PROJECT: City of Ferndale Thornton Street Sanitary Sewer Project

ADDENDUM NO. 1 To the Contract Provisions for CITY OF FERNDALE, WASHINGTON

THORNTON STREET SANITARY SEWER PROJECT CITY PROJECT NUMBER SS2015-03

Plan Sheet 3

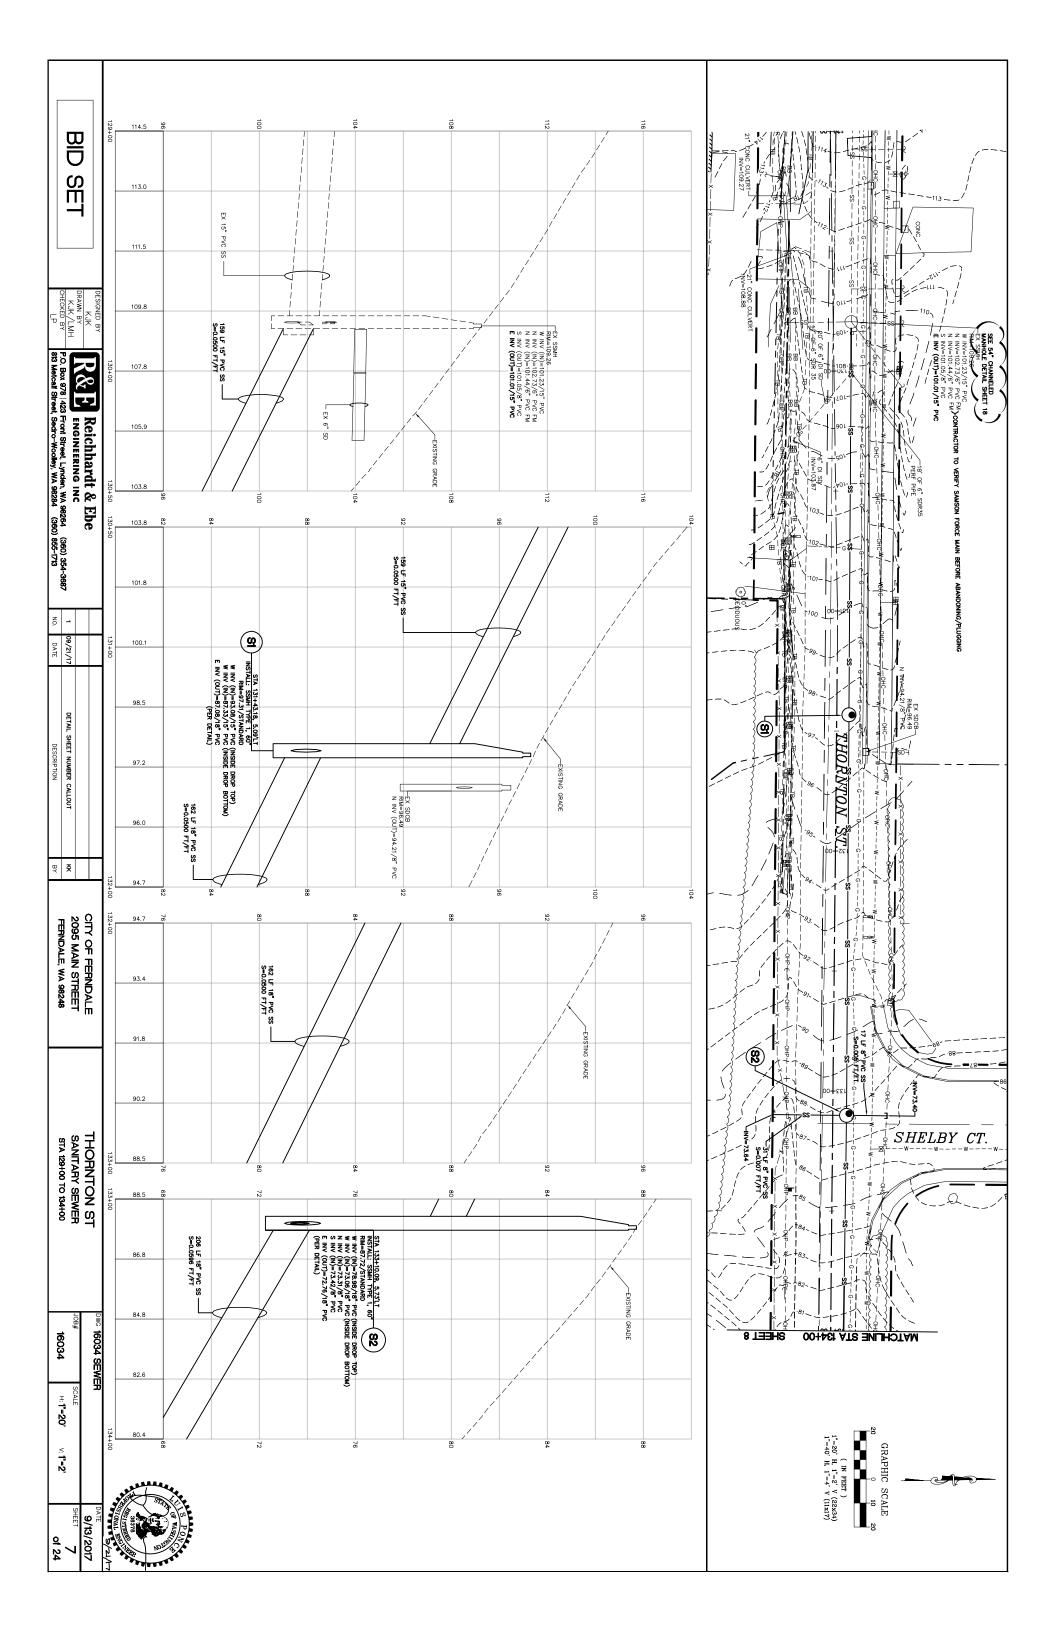
- The location of an existing culvert has been added.
- The location of the removed wire fence and post is noted.
- Silt fence was deleted between approximately STA 138+00 to 139+50.

Plan Sheet 4

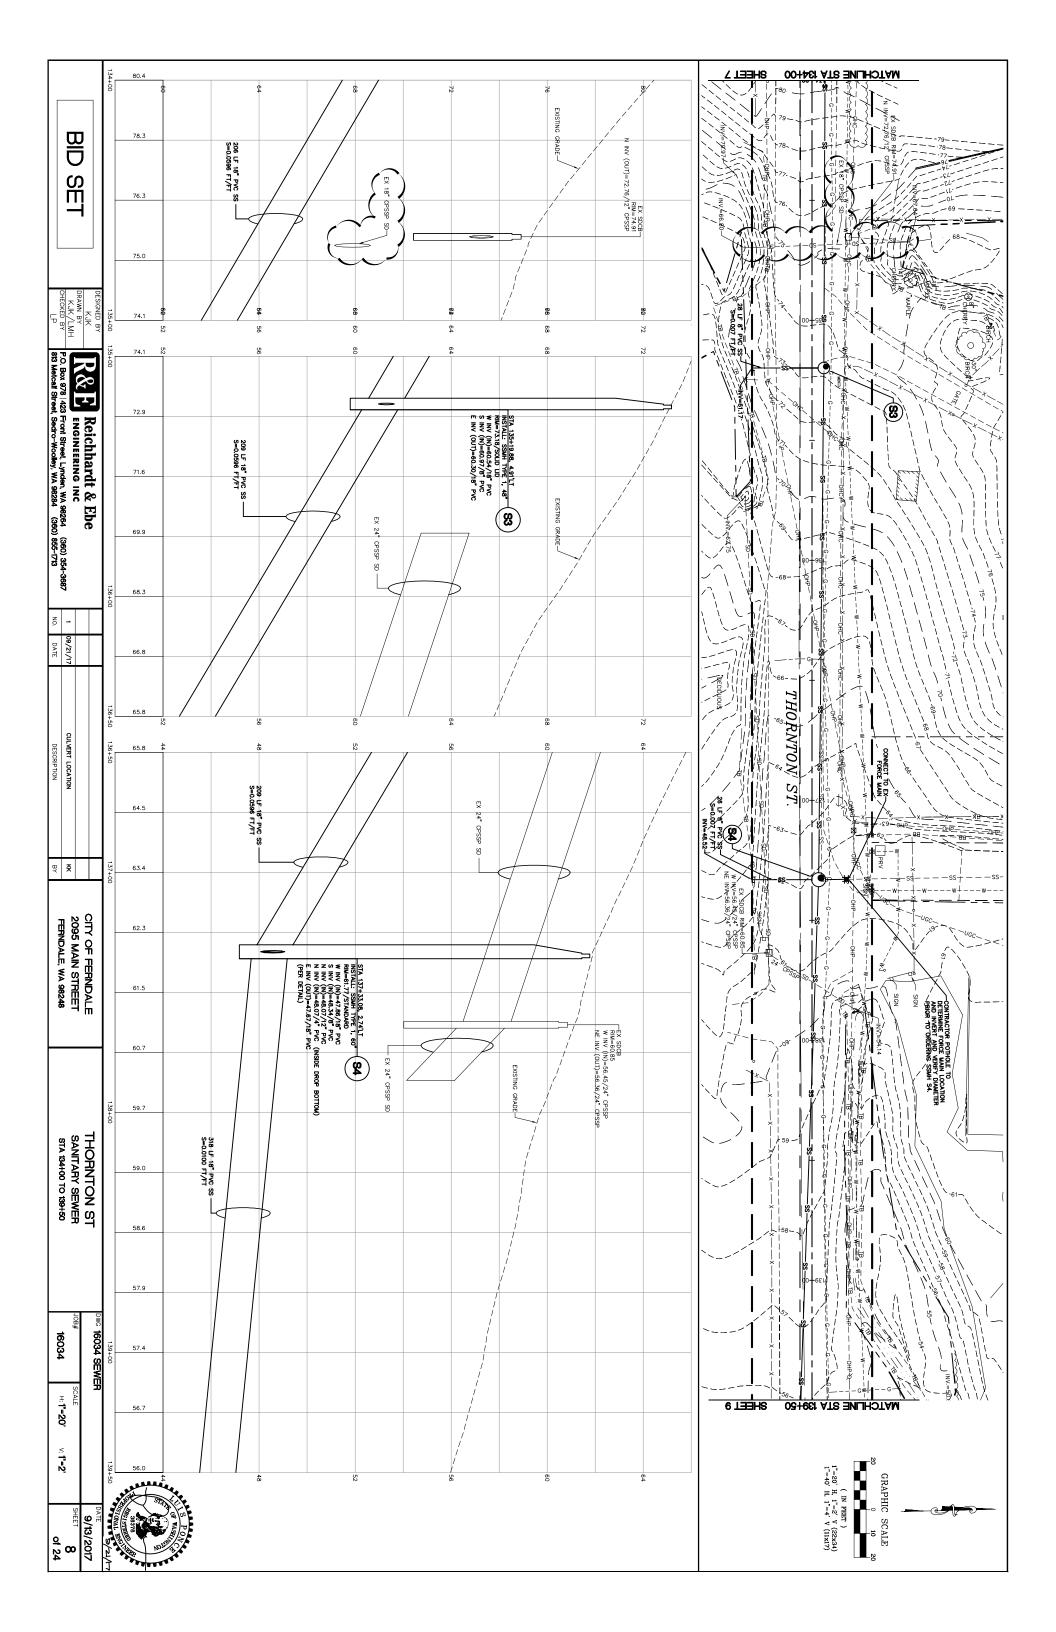
- The location of the removed wire fence and post is noted.
- The location of trees that shall be trimmed as trees overhang onto the proposed sanitary sewer trench is noted. A photo of the trees is also attached for Bidder's information.
